INDESIT company

WA10IT

F026880

Notices

n1040235: Restored the fixing of the anterior counterweight with platelets inserted in the tub

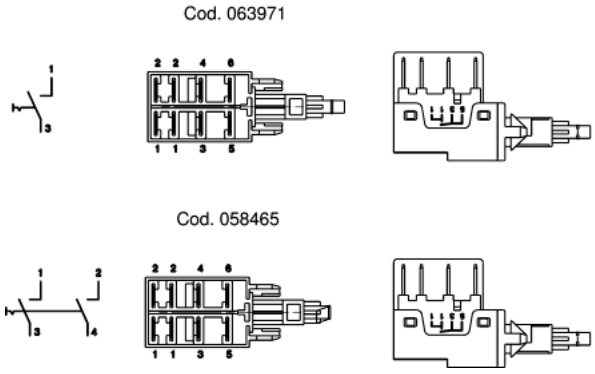
From the 11105.0001 registration number on the washing machines with plastic tubs produced in the Teverola factory, the fixing of the anterior counterweight is restored with platelets inserted in the tub instead of those realised with self-threading screws, the system described in Notice N1040184.
The tubs maintain the same SAT code and are provided with the following particulars:

N° 3 Screws code cod. 014342;
N° 3 Conical washer cod. 055018;
N° 3 Plain washer cod. 034336.

Whenever the necessity may arise on a tub, proceed with diverting the self-threading screws that block the anterior counterweight., as it's compulsory to execute the fixing again avoiding in time a possible loosening and thus the breaking of the tub by utilising the registered screws (cod. 014342), the conical washers (cod. 055018), the plain washers (cod. 034336) and the platelets (cod. 055038).

FIG. 1

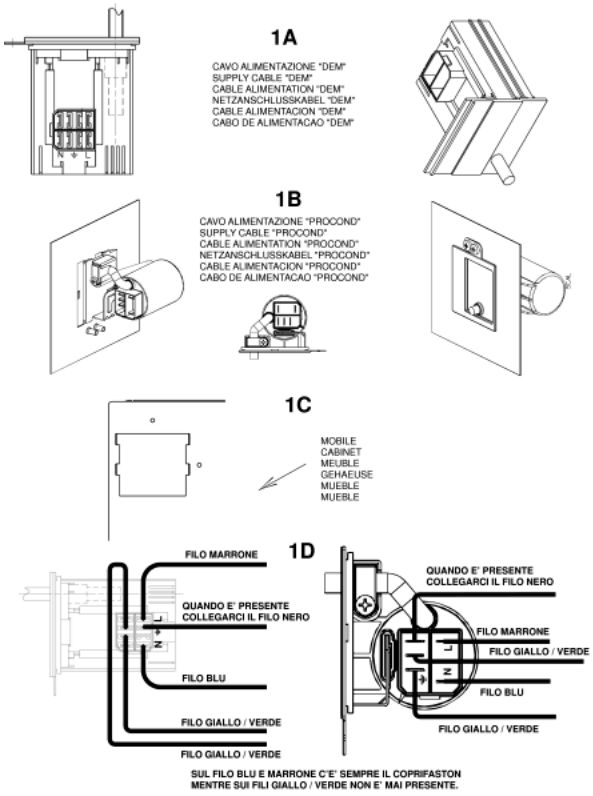
All appliances produced in the Comunanza (from serial no. 21008.0001), Teverola (from serial no. 21111.0001) and Brembate (from serial no. 21119.0001) factories have been equipped with power supply cables with integrally moulded filter (see fig.1 - 1A and 1B) and new units having a specific opening at the back for fixing the new cables (see fig. 1 - 1C).

The new units, together with the new cables, can be used in place of the premodification ones, by connecting the wiring to the cable, as shown in figure 1 - 1D.
The codes of the new units and of those replaced (ESI - table n1040276fig02), which will be managed until stocks run out, are given below.

The premodification wirings, are also managed for modified products by making the connection to the terminal block of the new cable as shown in fig. 1 - 1D.
The wiring diagrams given in the Documentation remain unchanged.

n1040279: Heater retaining element bracket and counterweight fixing

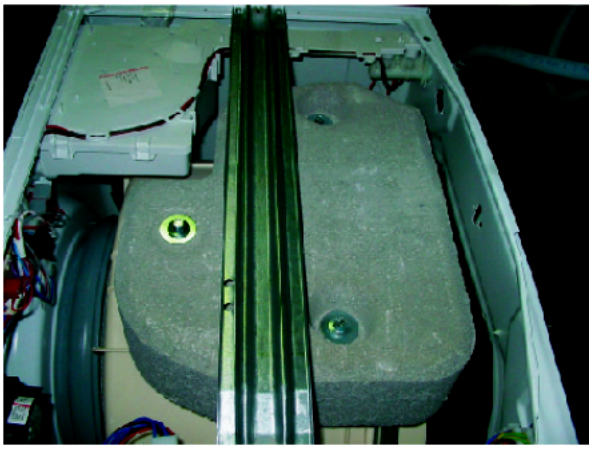
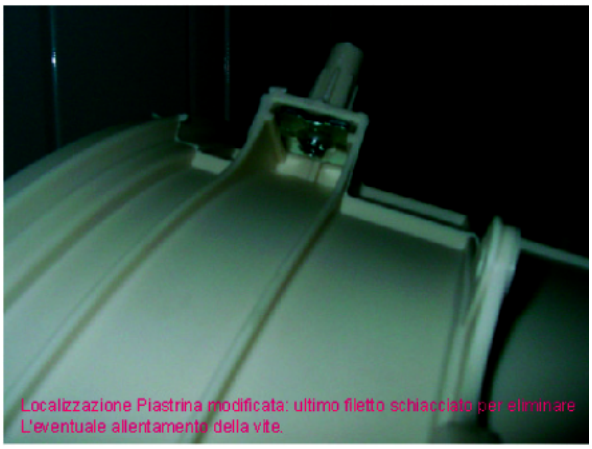
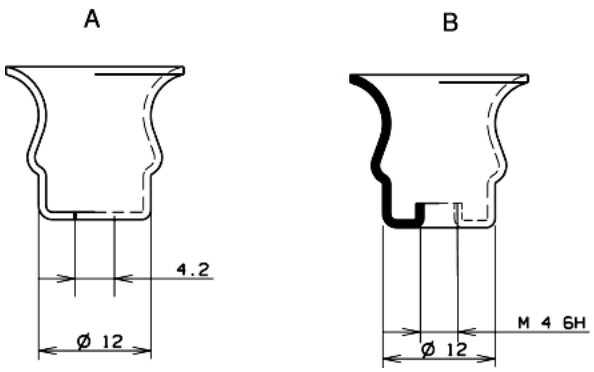
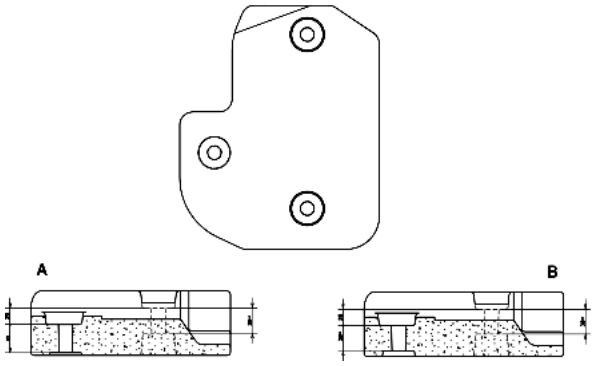
From serial no. 21015.001, a heater retaining element bracket (see fig.3) has replaced the heater retaining element protection Sat code 055036 (see fig.4) on all plastic tanks installed in washing machines produced in the Teverola factory.
The new part (fig. 1A) is fixed to the bowl with a self-tapping screw from the inside outwards and differs from the one used in the Comunanza factory (fig. 1B) in the fixing hole which is not threaded.
In order to reduce the number of parts used, only kit 058523 is managed and which, if used on the Teverola washing machines, must be fixed with a self-tapping screw, instead of metric, after widening the tapped hole with a suitable drill bit.
When inserting the heater retaining element, particular care must be taken so that it is fitted correctly (Fig. 3).
The plastic tanks to be arranged for the guide have the same Sat code as those with the protection.

>From serial no. 21121.0001, the counterweight Fig. 2B with outlet increased by 5 mm in the centre has replaced the previous counterweight Fig. 2A.
The new counterweight (fig. 5) is fixed using three M8 X 63 mm screws with washer code 092016 (see fig. 8) and three plates with the last thread flattened (fig. 6) to prevent accidental loosening of the screw.
All the plates code 055038 in stock in the Centralised Warehouse have been replaced and can also be used on premodification appliances.
The modified counterweight has the same Sat code as the premodification item (066615) that will be managed until stocks run out.
The new counterweight must be assembled using the new screws and plates (see fig. 7).
Both counterweights can be employed necessarily using the following fixing parts which are specific for each type of counterweight:

Fixing parts for premodification counterweight (see fig. 9):
3 pieces code 055019 - Screw M8 X60 mm;
3 pieces code 055018 - Conical washer;
3 pieces code 034336 - Flat washer;

Fixing items for modified counterweight:

3 pieces code 092016 - Screw M8 X 63 mm with washer;
3 pieces code 055038 - Plate with last thread flattened;

FIG. n1040305fig01

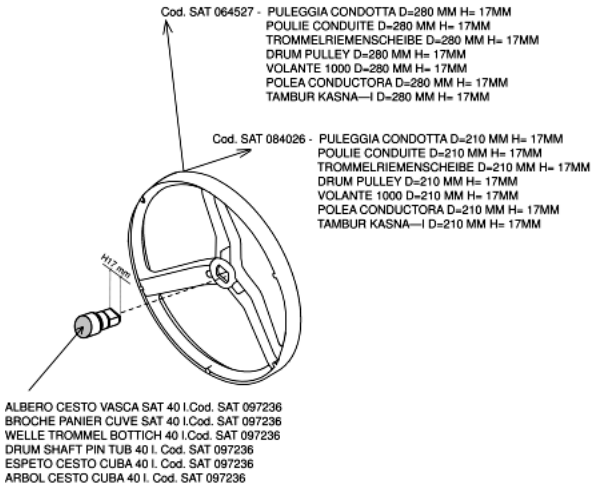
·Eeproms - The new software for the 40 litre EVO washing machines can also be used on premodification appliances; it is managed with the same Sat codes as the previous software, which is being immediately replaced as the new models enter into production.
·Pulleys - The use of a single 40 litre bowl assembly in Assistance involves management of the pulleys used in production (097268 and 097267) and also those required for creating the various combinations (see fig. n1040305fig.01):

Code 064527 - Pulley D=280mm H=17 mm;
Code 084026 - Pulley D=210mm H=17mm.
